ADDENDUM No. 2

RFP No. 23-17

STREET RESURFACING PROJECT – 2023 Due: May 17, 2023, at 10:00 A.M. (local time)

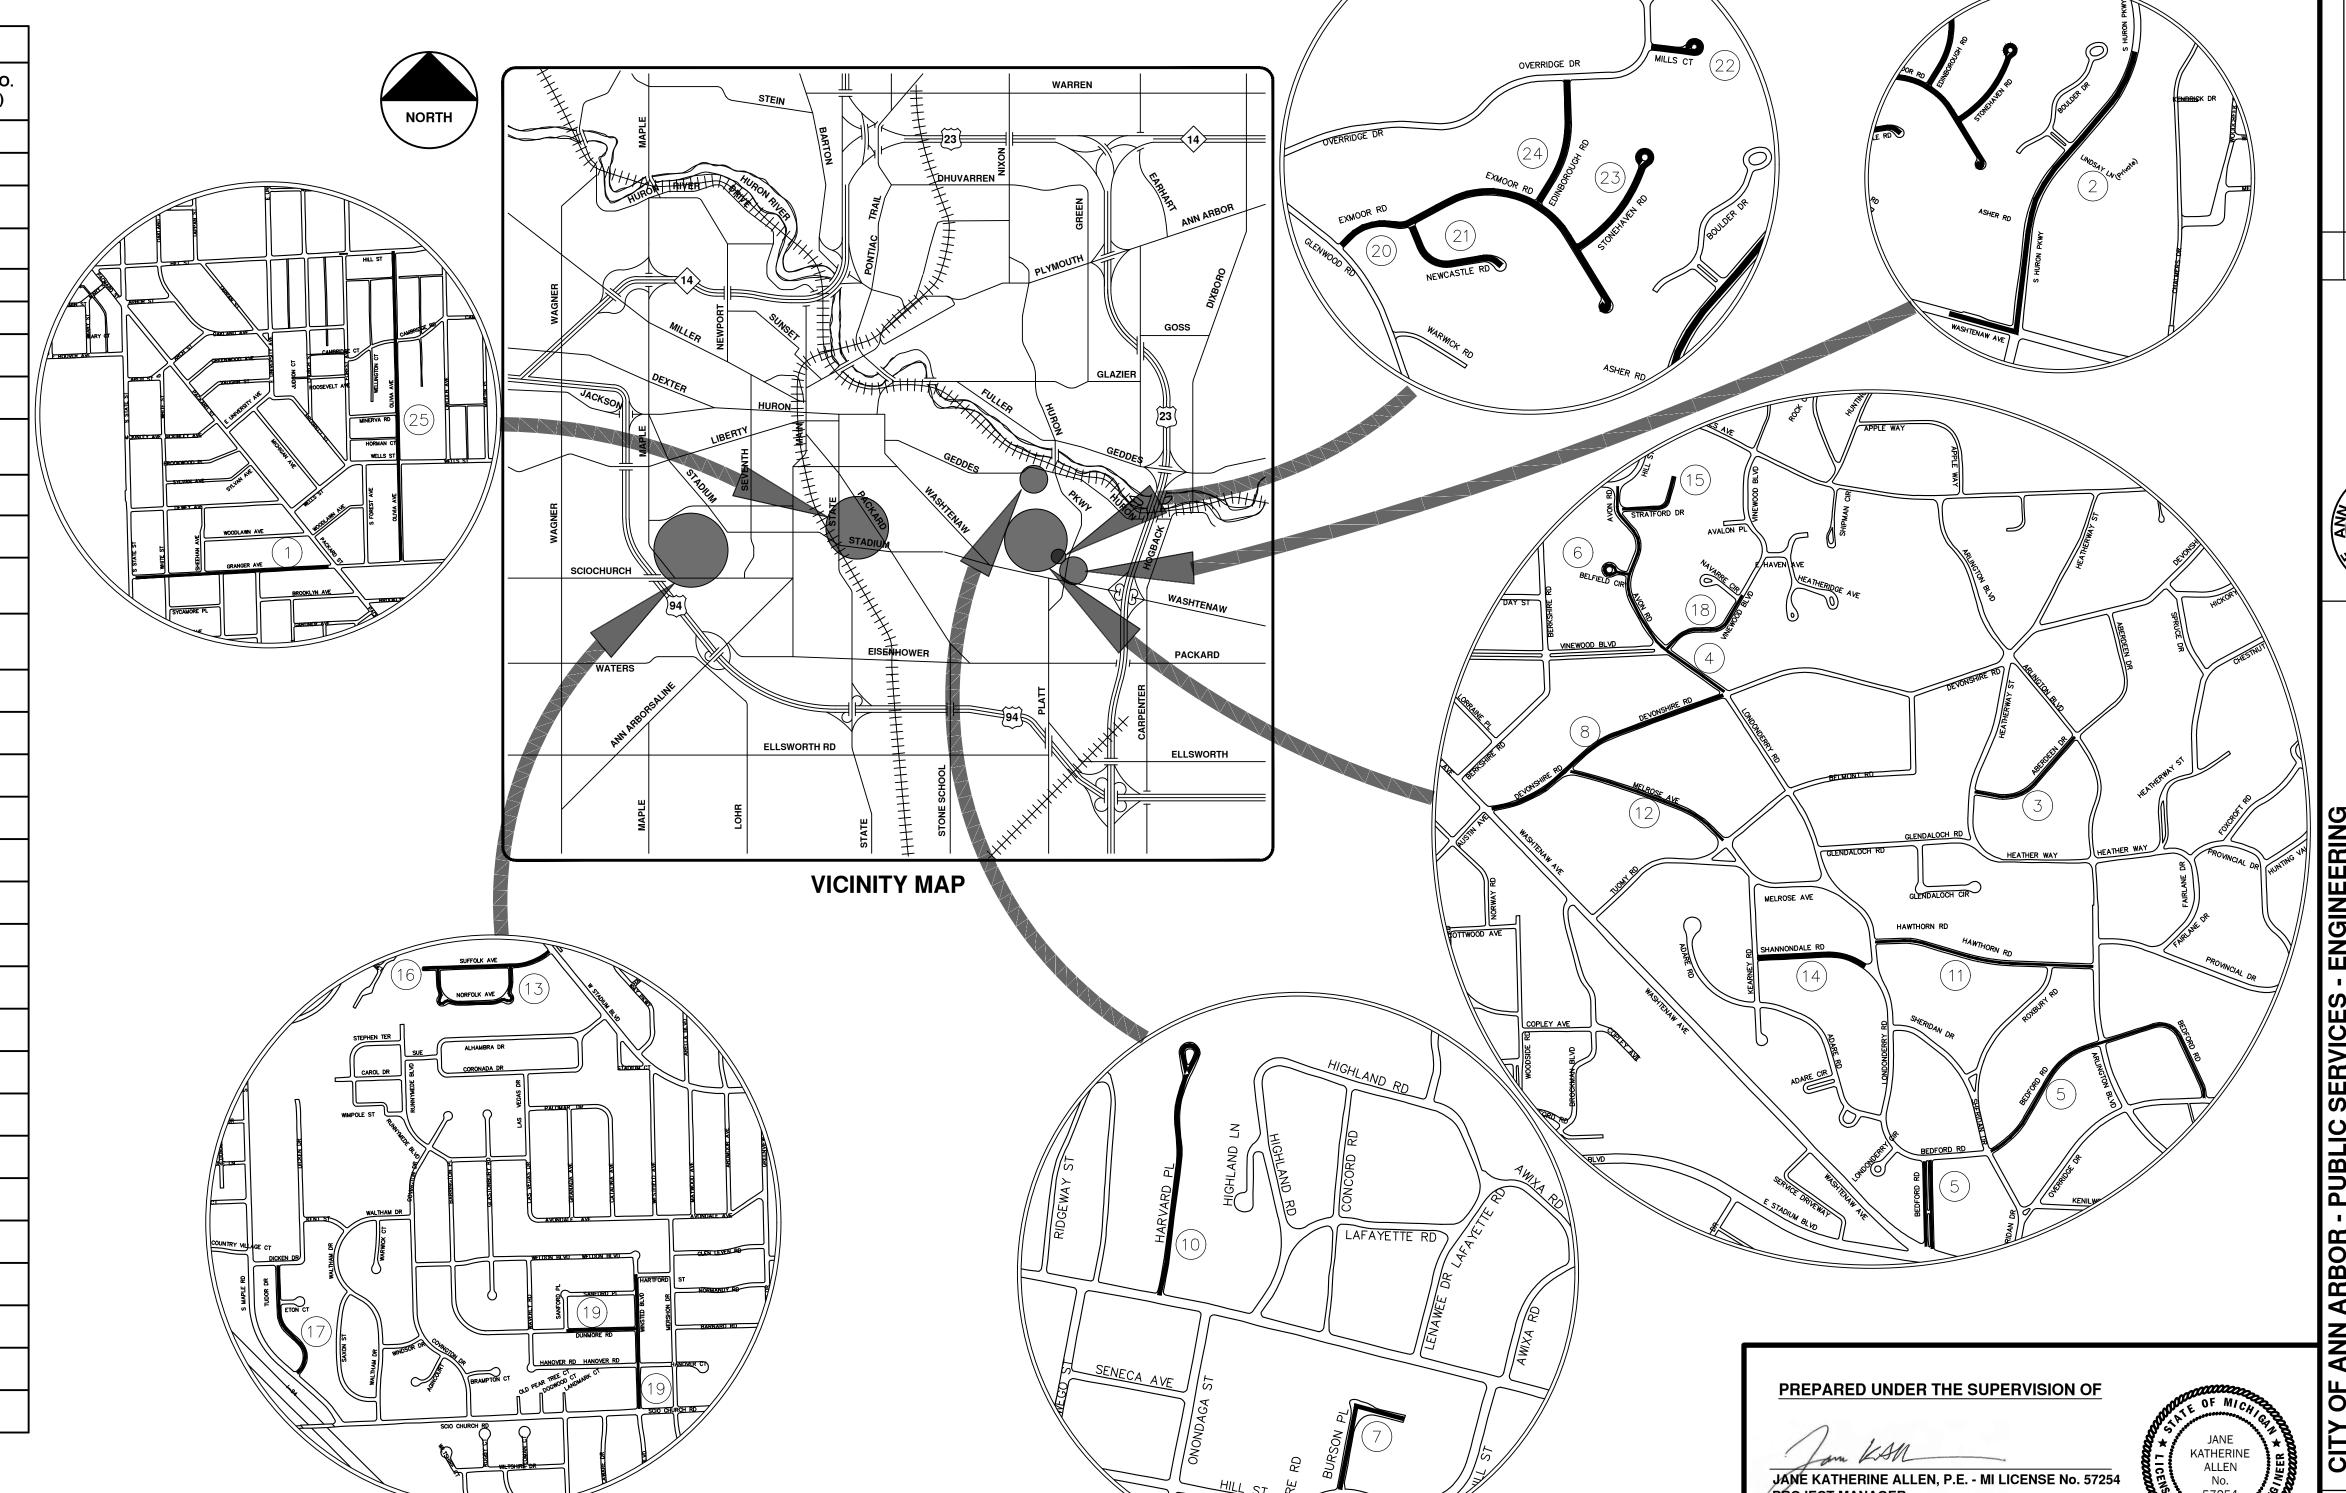
Sheet 1 Updated area maps to show Exmoor Rd., Newcastle Rd.,

Edinborough Rd., Stone Haven St., Mills Ct. and Olivia Ave. Added Exmoor Rd., Newcastle Rd., Edinborough Rd., Stone Haven St. and Mills Ct., Olivia Ave. and Granger Ave. to the sheet index.

STREET RESURFACING PROJECT - 2023 CONCRETE SPEED HUMP DETAIL
--

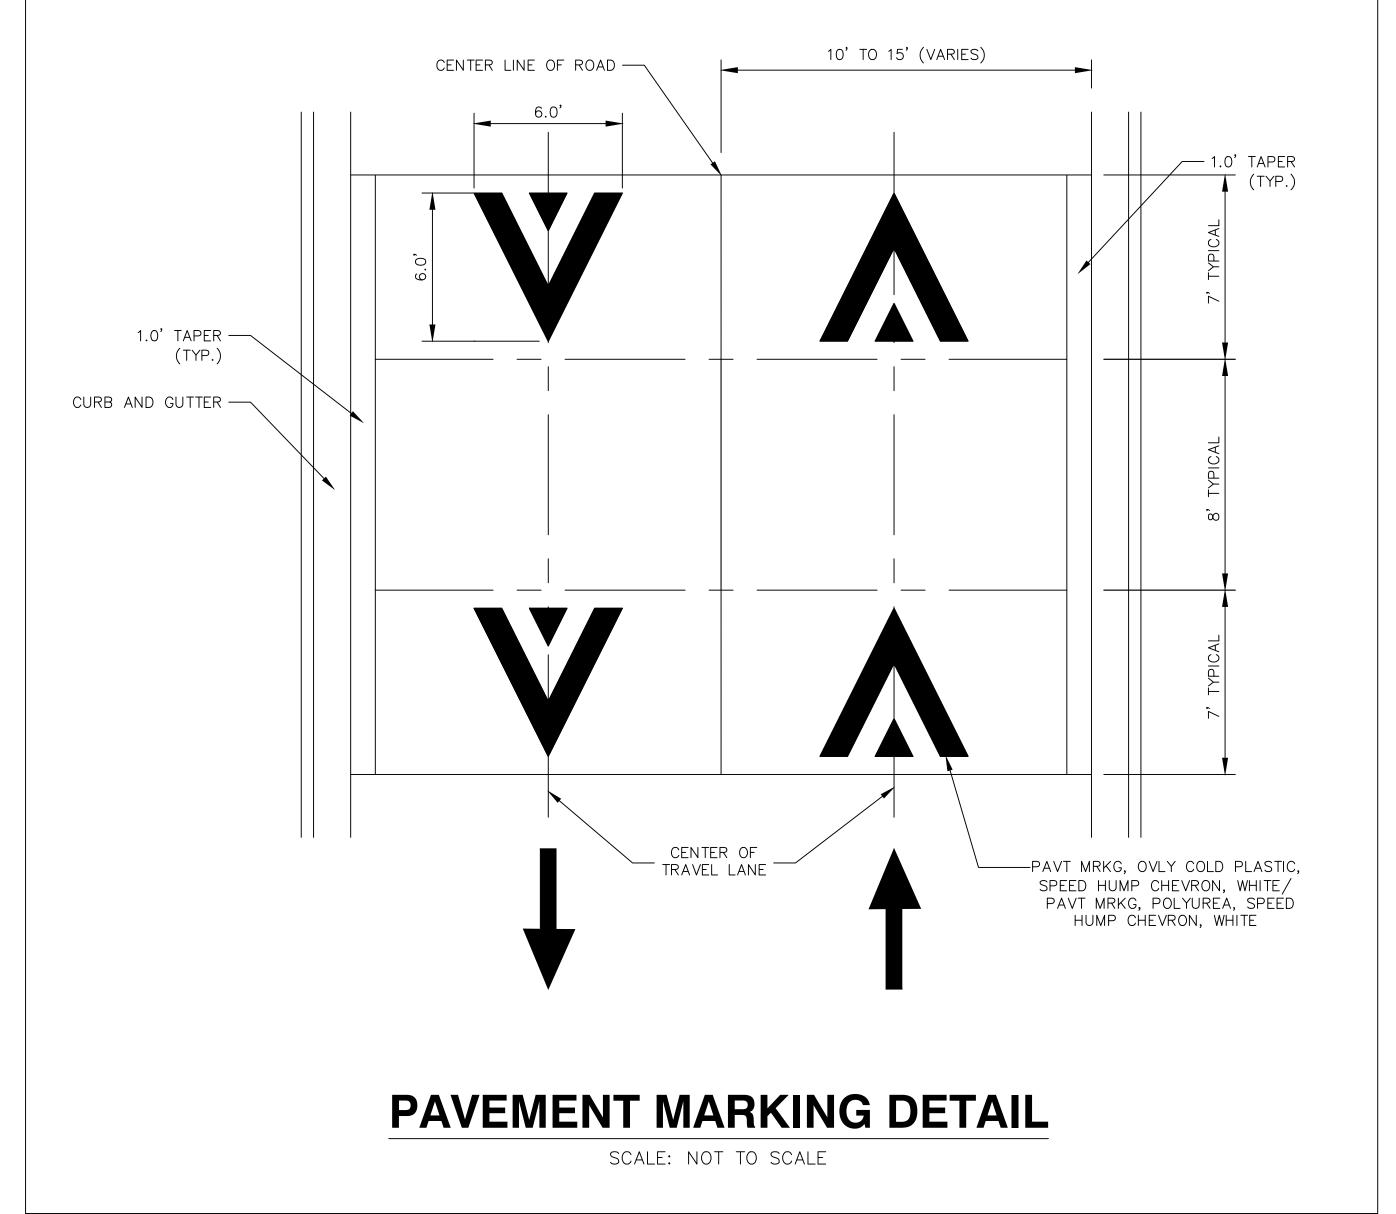
Sheet 07 - Concrete Speed Hump Detail Sheet 08 - Concrete Speed Table Detail Sheet 09 - Concrete Raise Cross Walk Detail Sheet 10 - Concrete Raise Intersection Detail

Answer 3: The sections were added. Reference updated plan sheets which are part of this addendum.
